1554 W 25TH ST
Permit Number :BMS40605
Status : APPROVED

Owner : THEODORE GELMAN &W ELLEN
Applicant : WAAS PHILLPS CONSTRUCTION CO.
Applicant Addr : 5528 NW. 79TH AVENUE
MIAMI, FLORIDA 33166
Phone number : 305/592/9574
Class code : REVIS 0
Valuation :
Construction : OTH
Permit to do : PLANS REVISION PERMIT #B9300428
Job Address : 1554 W 25TH ST

Permit No: B9300428 REMODELING & ADDITION
Applicant: THEODORE GELMAN & W. ELLEN
Location: 1554 W 25TH ST

RE: THE GELMAN RESIDENCE ADDITION
1554 West 25th Street
Sunset Island #2

SECOND FLOOR FRAMING PLAN

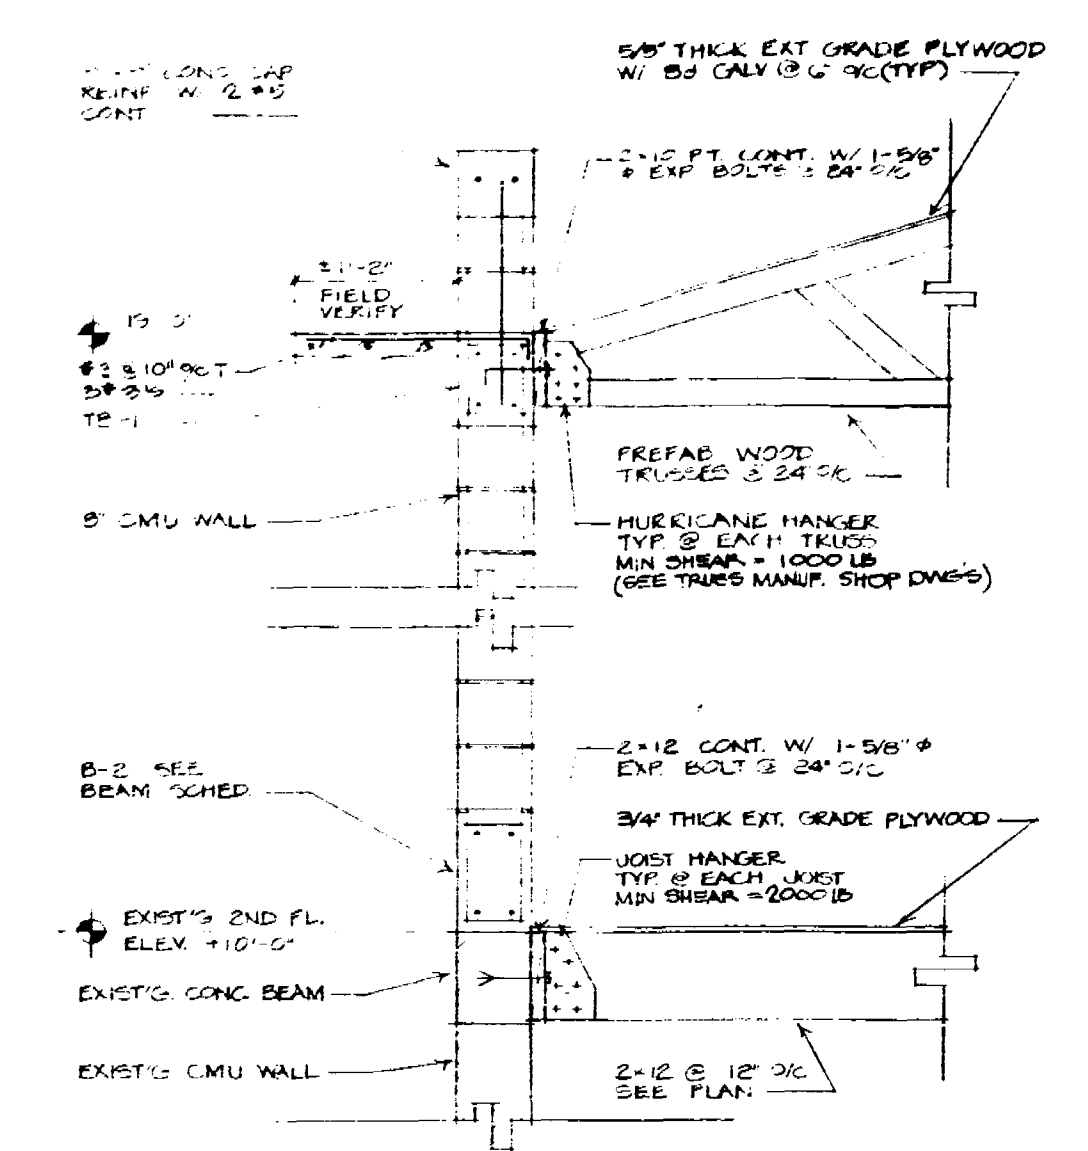
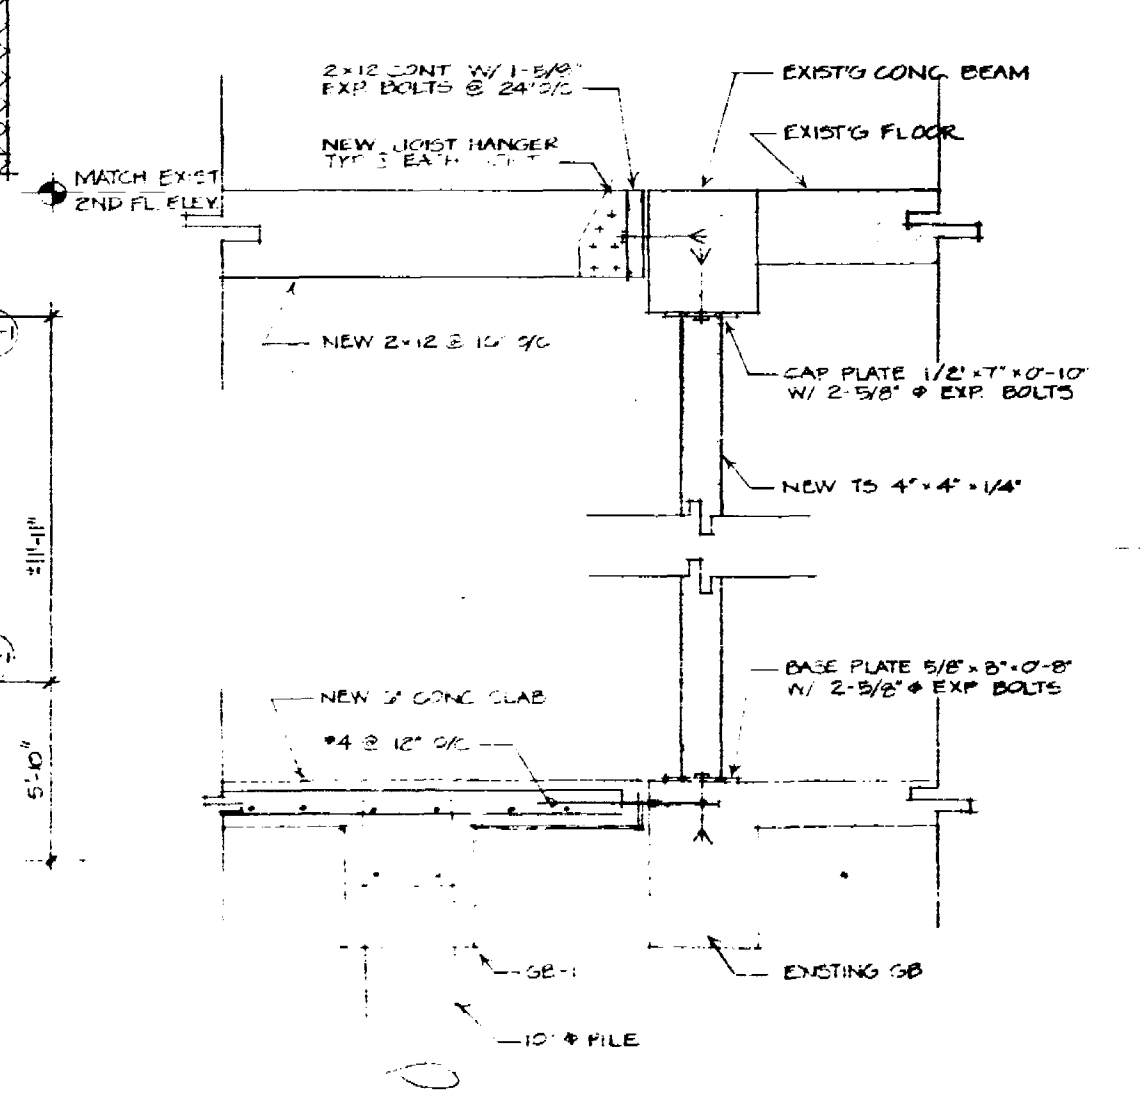
No	Date	User	Comment Text
1	01/11/94	BLDGADMN	PLEASE CLARIFY.
2	01/11/94	BLDGADMN	JF-12 PROVIDE CALCULATIONS FOR ALL LEDGERS USED. VALUES
3	01/11/94	BLDGADMN	PERPENDICULAR TO GRAIN ARE LOW.
4	01/11/94	BLDGADMN	JF-13 SECTION 1/S-2, MUST SPECIFY WHAT TYPE OF TRUSS
5	01/11/94	BLDGADMN	HANGER IS TO BE USED, AND THE REQUIRED NAILING.
6	01/11/94	BLDGADMN	JF-14 PLEASE ADDRESS ALL ITEMS ABOVE, REVISE DRAWINGS AS
7	01/11/94	BLDGADMN	REQUIRED, AND RE-SUBMIT, FOR COMPLETE REVIEW. TOO
8	01/11/94	BLDGADMN	MANY ITEMS TO CONTINUE REVIEW. PLEASE RE-SUBMIT.

ROOF FRAMING PLAN

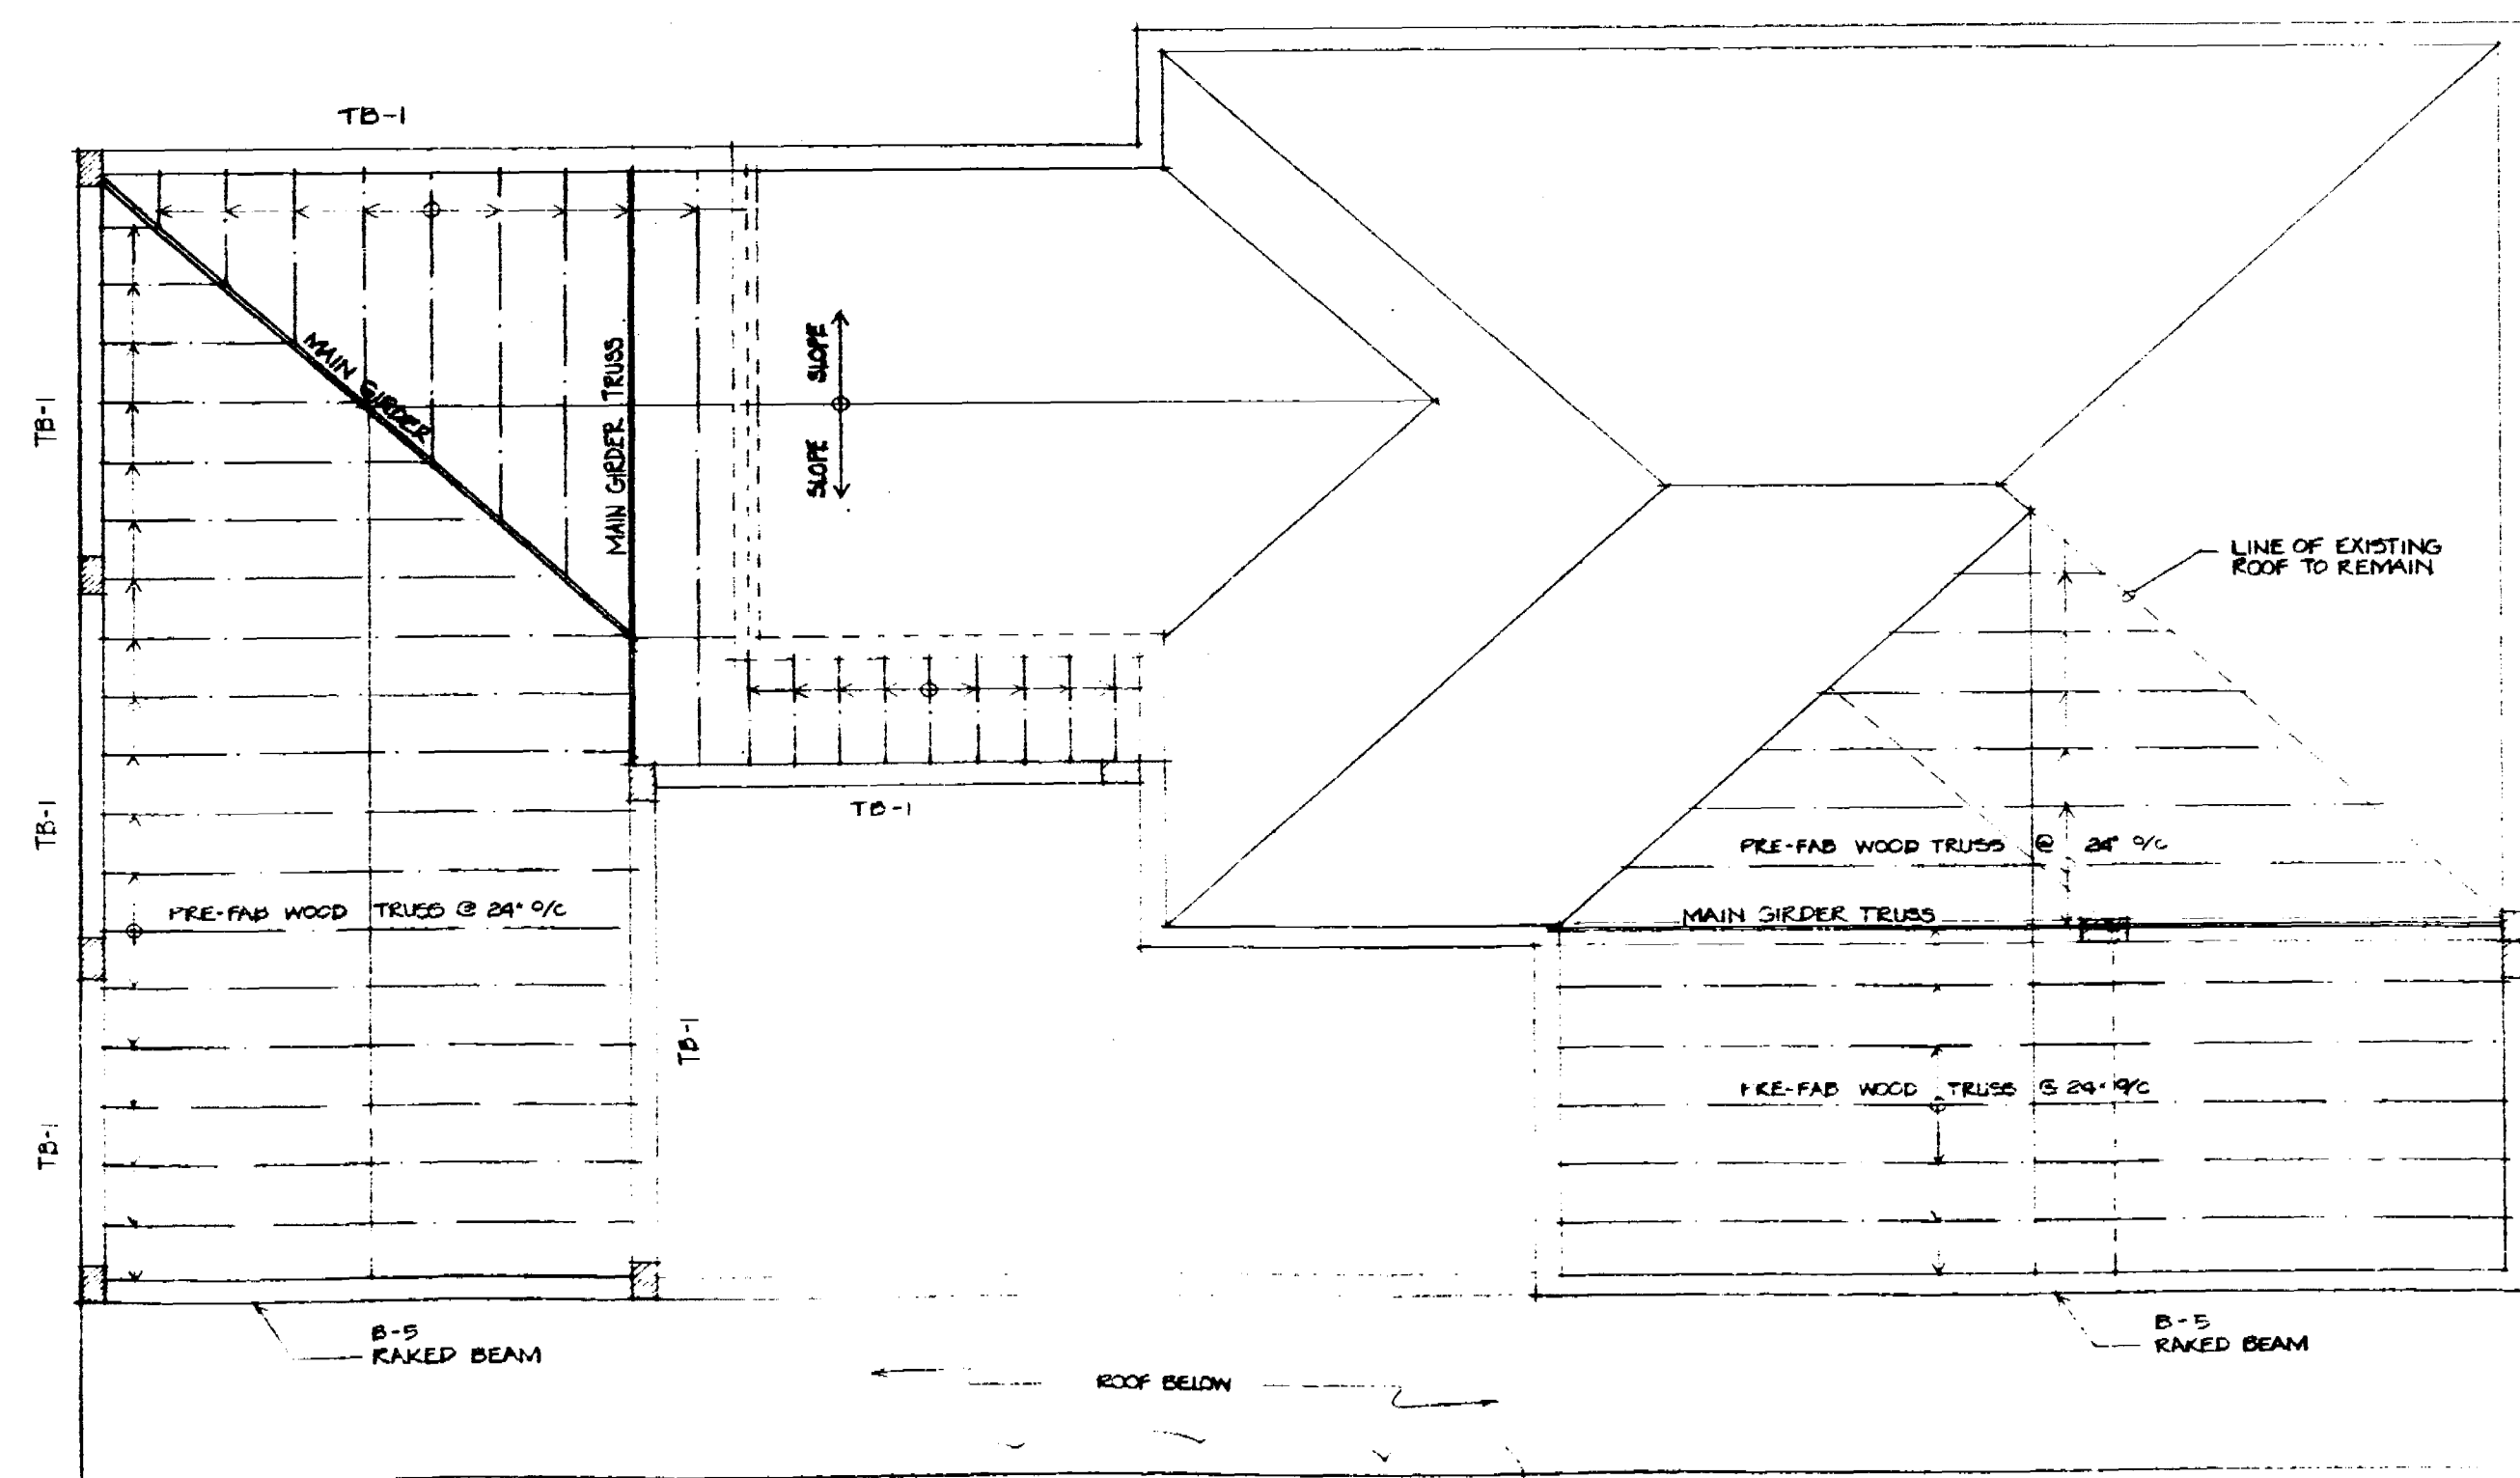
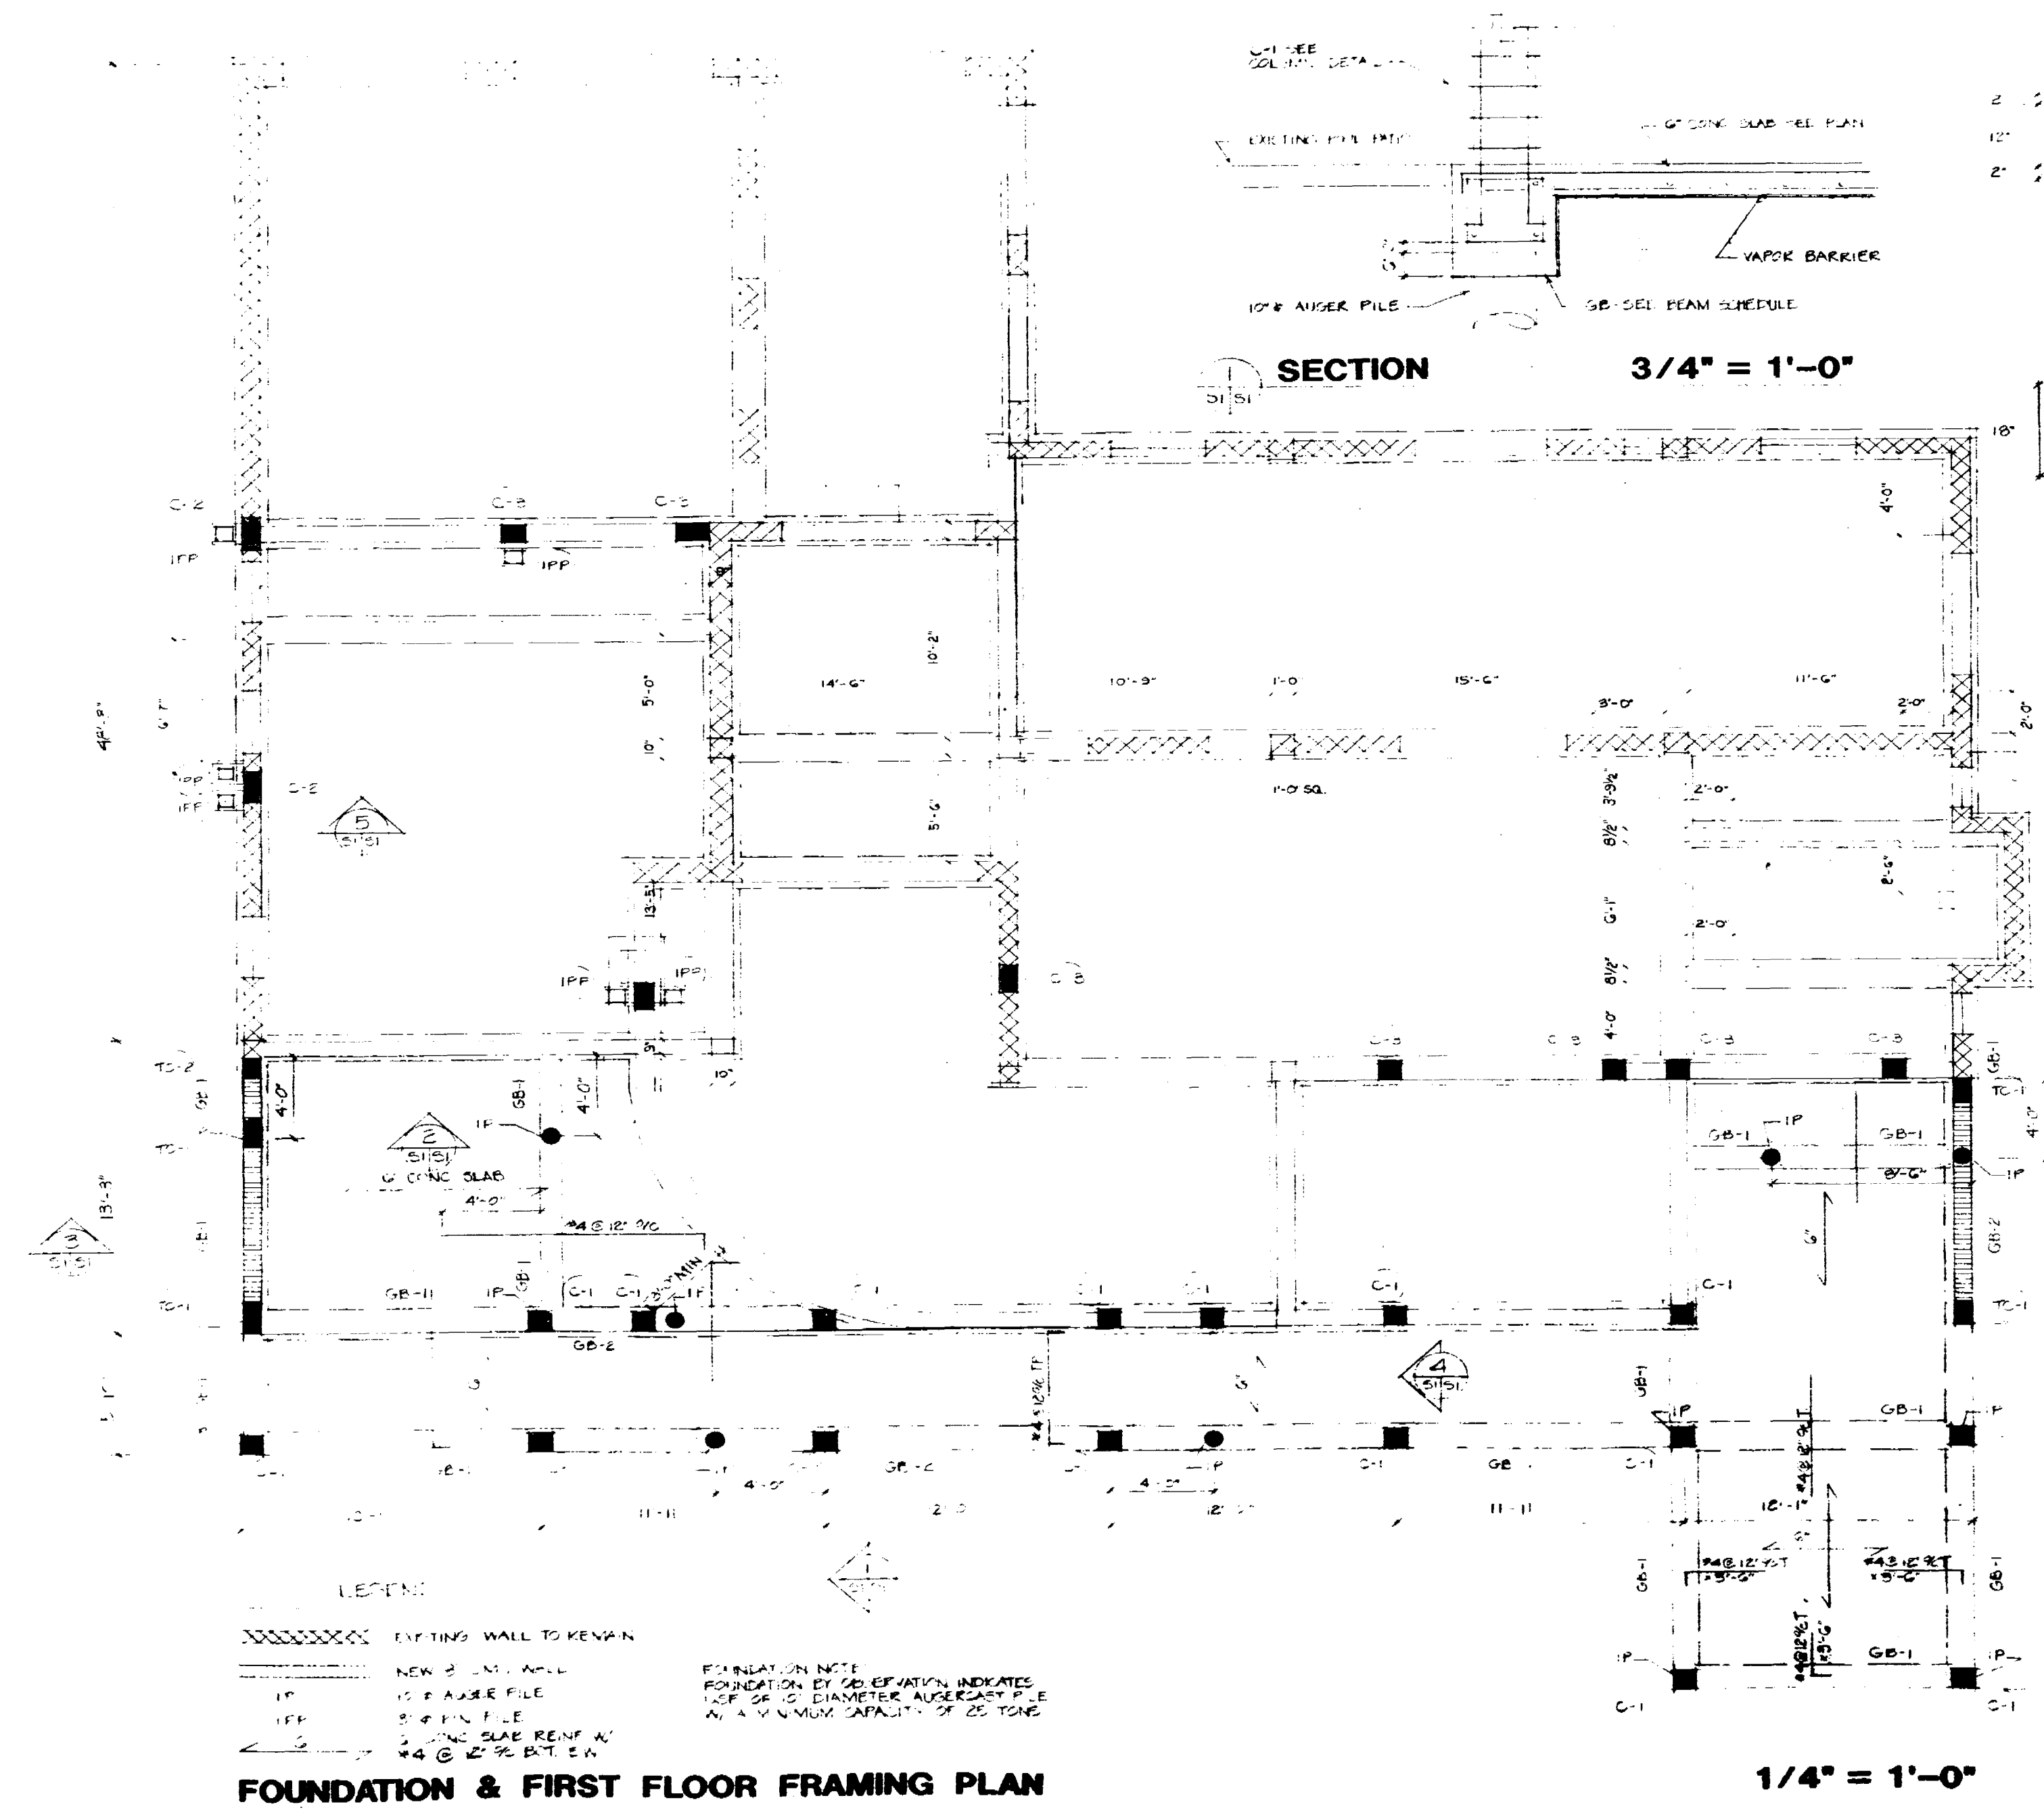
No	Date	User	Comment Text
1	011194	BLDGADMN	JF-6 PROVIDE ALLOWABLE ECCENTRICITY FOR AUGERCAST PILES,
2	011194	BLDGADMN	AND HOW IS THIS ECCENTRICITY RESISTED.
3	011194	BLDGADMN	JF-7 HAS IT BEEN ESTABLISHED THAT ALL OF THE EXISTING WALLS
4	011194	BLDGADMN	THAT ARE TO BE REMOVED ARE NOT LOAD BEARING ?
5	011194	BLDGADMN	IF NOT, THIS SHOULD BE FIELD VERIFIED.
6	011194	BLDGADMN	JF-8 SECTIONS 4 AND 5 S1, PROVIDE SPECS FOR DRILLING AND
7	011194	BLDGADMN	EPOXY OF REINFORCING INTO EXISTING.
8	011194	BLDGADMN	JF-9 FOR ROOF TRUSSES, PROVIDE REQUIRED GRAVITY LOADS AND
9	011194	BLDGADMN	NET WIND UPLIFT FOR DESIGN, BY TRUSS MANUF.
10	011194	BLDGADMN	JF-10 PLEASE SHOW IN PLAN, IN DRAWINGS, THE VERTICAL
11	011194	BLDGADMN	REINFORCING ADJACENT TO ALL OPENINGS.
12	011194	BLDGADMN	JF-11 C/A8 SHOWS 2X12 RAFTERS AT 24", S-2 SHOWS 2X10 AT 24".
